## Responses to the reviewers

**Title:** Identification, Mapping and Eco-hydrological Signal Analysis for Groundwater-dependent Ecosystems (GDEs) in Langxi River Basin, North China (hess-2023-151)

Line 563 to 571:

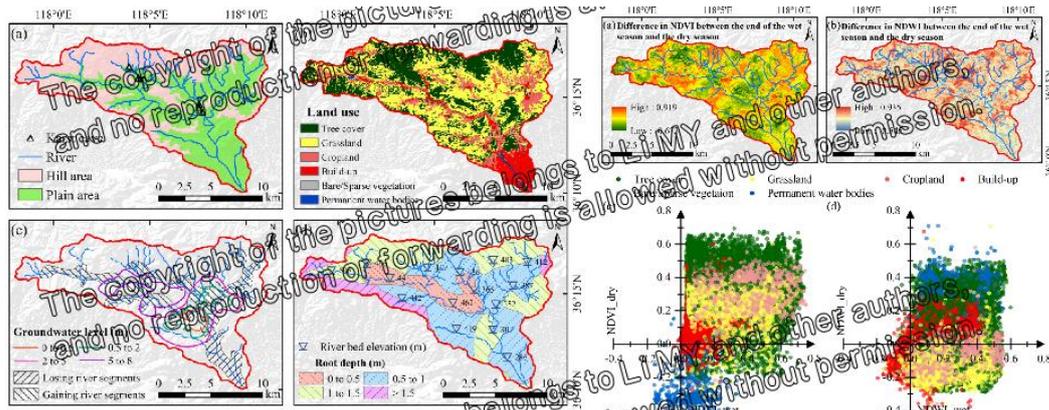
2. The author used data from 2020 to 2021 to divide the scope of GDEs in the Langxi River Basin. This seems to be because the author conducted the experiment during this period. Does this method also work at other times?

Answer: Thank you for your question. First of all, the distribution range of GDEs will change with the amount and range of groundwater recharge. The amount and extent of groundwater recharge will slowly change with the impacts of climate change and human activities. When natural disasters such as earthquakes, coal mining, or human activities cause serious changes in underground aquifers, the distribution range of GDEs may change significantly in a short period of time. During the period when the

stratum does not change significantly, long-term groundwater level monitoring data shows that the changes in groundwater levels in the entire LRB and its vicinity are very weak. Therefore, we believe that the distribution range identification method of GDEs proposed in this article is representative. It should be noted that when the groundwater level fluctuates significantly or the stratigraphy changes significantly, we recommend re-evaluating the relevant indices and parameters in the study area and this system.

We have added relevant discussion of this situation in the Discussion section of the paper.

The quantity and range of groundwater recharge will affect the GDEs' distribution range. The effects of climate change and human activity will gradually alter the volume and scope of groundwater recharge. The distribution range of GDEs can alter dramatically in a short amount of time when major changes are made to subterranean aquifers by natural disasters like earthquakes, coal mining, or human activity. It should be noted that when the groundwater level fluctuates significantly or the stratigraphy changes significantly, we recommend re-evaluating the relevant indices and parameters in the study area and this system. Long-term groundwater level monitoring data indicates that the changes in groundwater levels in the entire LRB and its vicinity are very weak during the period when the stratum does not change significantly. Therefore, the Four diagnostic criteria framework proposed in the study can effectively identify GDEs in areas such as grasslands, deserts, plains, and karsts in arid, semi-arid, and sub-humid areas.

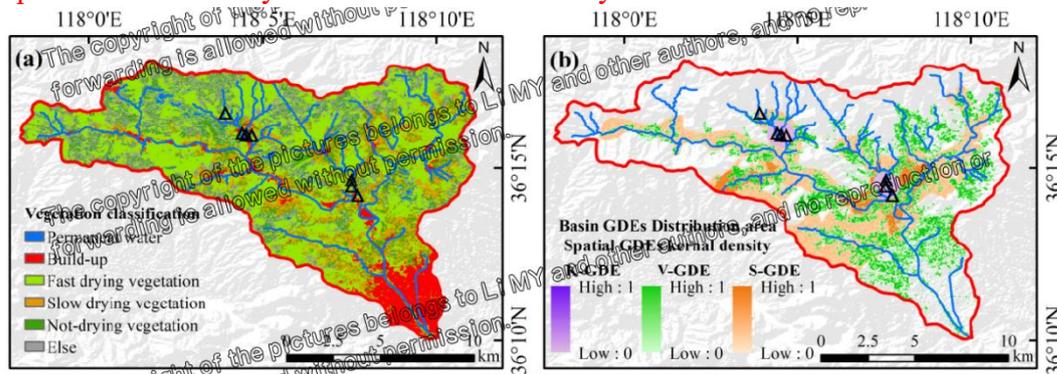
3. The Langxi River Basin is a typical study area selected by the author. Is the GDEs identification and mapping framework proposed by the author also applicable to other river basins? I think this is also an interesting question for other readers.

Answer: We understand that readers will consider whether this approach can actually be applied to other basins. We subsequently conducted relevant experiments in another Chinese karst area, the Tanglang River Basin (TRB), and used this framework to classify GDEs. We will show you some of the results here.

First, we collected and organized relevant data on TRB and divided plains and mountains. Land use types, groundwater levels, water gaining and losing reaches, river bed elevation, and vegetation root systems of the TRB were investigated. The vegetation index at the end of the dry season and the wet season is used to classify crops, plants that lose water quickly, plants that lose water slowly, evergreen vegetation and buildings, etc.

The GDEs distribution characteristics of TRB can be further calculated by using the spatial kernel density method used in this study.

It should be noted that the identification, drawing and verification framework we proposed has been transplanted from LRB to TRB and has also been improved accordingly. First of all, because there are a large number of population centers and cities in TRB, we added the identification of construction land to the identification framework of GDEs. Secondly, compared with LRB, TRB has more karst caves. During the verification process of water bodies, we added work such as sampling of cave fissure water and aquatic life inside and outside caves. This can make the verification more convincing. In subsequent research, by incorporating hydrological (ecological hydrological) models that consider groundwater, and conducting source analysis of water chemistry, isotopes, and sediment, a series of research accuracy such as the identification and mapping of GDEs can be improved.

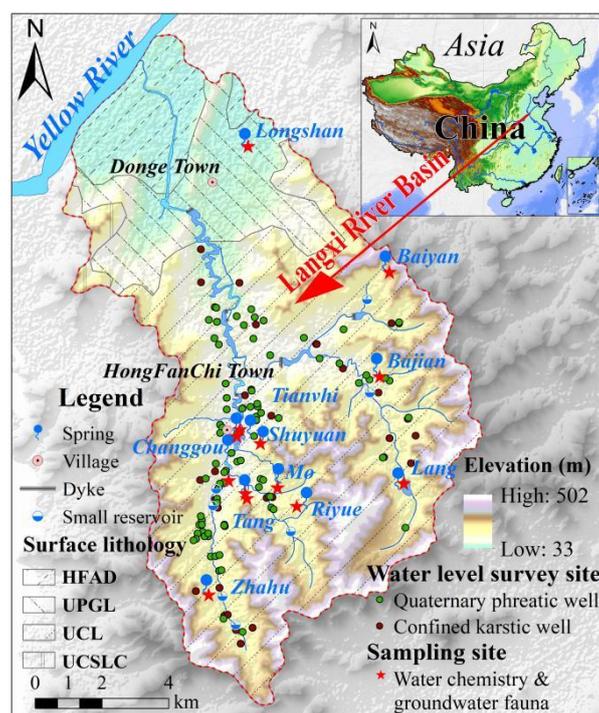
5. The study area map of Line 710 in Figure 1 should be redesigned. It's not pretty now.

**Answer:** We modified Figure 1, adjusted the layout, and replaced the more difficult-to-understand geological symbols with abbreviations.

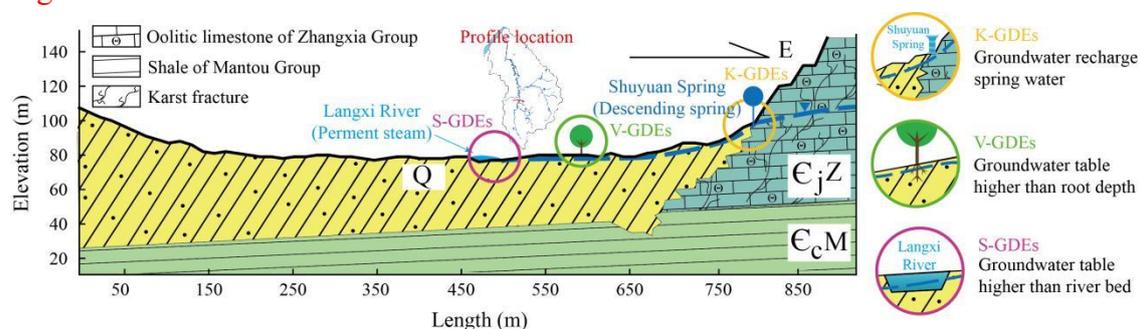
2. The current version lacks substantial supporting information on ecohydrological signals aiding in mapping GDEs. Section 3.4 primarily focuses on the spatial distribution of GDEs within the study area. Sections 3.5 and 3.6 delve into detailed descriptions of hydro-biogeochemical features observed in GDEs. However, there appears to be a weak connection between these descriptions and the verification of various GDEs, as depicted in Figure 2. Strengthening this connection is essential for a more cohesive presentation of the study's findings regarding the role of ecohydrological signals in GDE mapping.

(1) The section shown in Figure 2 has important connections with Section 3.3.1. Section 3.3.1 describes the lateral recharge relationship of groundwater to the Langxi River. In response to this, this study conducted a geological survey on the Shuyuan Spring and Langxi River sections, and explored the relationship between the groundwater level and Shuyuan Spring, as well as relevant information about the stratigraphy of the sections. In the text, we reformulate the connection between Figure 2 and Section 3.3.1. And in order to increase relevance, we modified Figure 2 to more clearly represent the three types of GDEs present in the modified typical section.

The Shuyuan Spring and Langxi River profile (hereinafter referred to as the Shuyuan Spring profile, Figure 2) shows the location and elevation relationship between groundwater and the Langxi River profile. The eastern Cambrian Zhushadong-Zhangxia Formation limestone is rich in groundwater buried deeper than the river. Shuyuan Spring, one of the descending springs in the basin, gushes out at the intersection of the Quaternary sedimentary layer and the Cambrian Zhushadong-Zhangxia Formation limestone. At the same time, groundwater also recharges to the Langxi River along the stratigraphic fissures.

Figure S1. Different slopes distinguish the plain and hilly results of LRB.

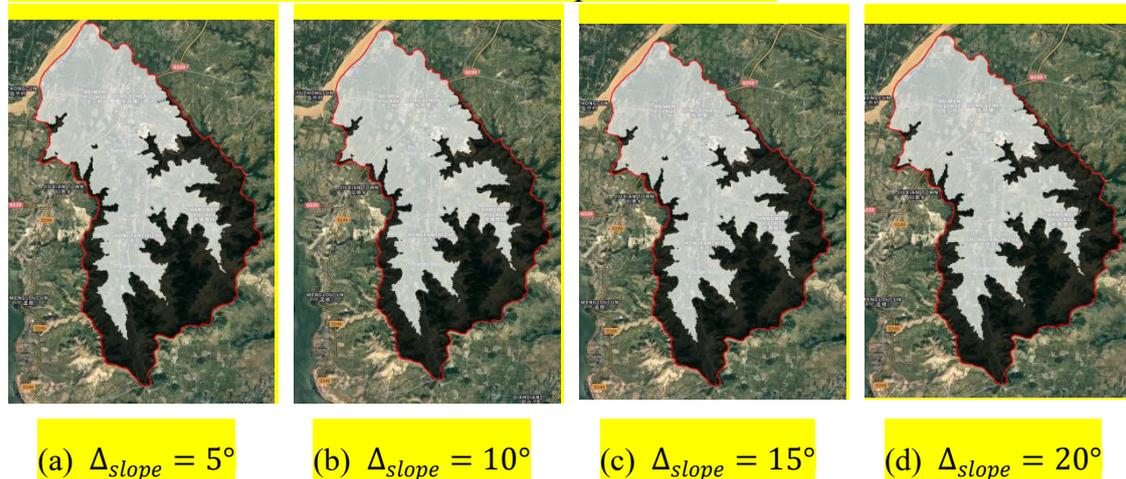
Page 6, Line 183: Please clarify the scale behind select a 10-degree angle.

Answer: In the original article, we briefly stated "The determination of this parameter can be manually adjusted based on one-third of the average slope of the basin until the plains and mountains are clearly distinguished." In response to experts' suggestions, we first put the method of parameter determination and the results of selecting different parameters into a supplementary file. This will allow readers to better understand my approach.

where,  $grid_{plain}$  represents the grid divided into plains;  $\Delta_{slope}$  is the threshold of the maximum plain slope, in this paper we take  $\Delta_{slope} = 10^\circ$ . The determination of this parameter can be manually adjusted based on one-third of the average slope of the basin until the plains and mountains are clearly distinguished (See Supplementary material I).

Below, Figure S1 shows our results of plain and hill classification using 4 different slopes. It can be seen that except for minor differences in details, overall slope does not have a great impact on plains and hills in LRB. This is due to the fact that the mean elevation limits the role of slope in this basin.
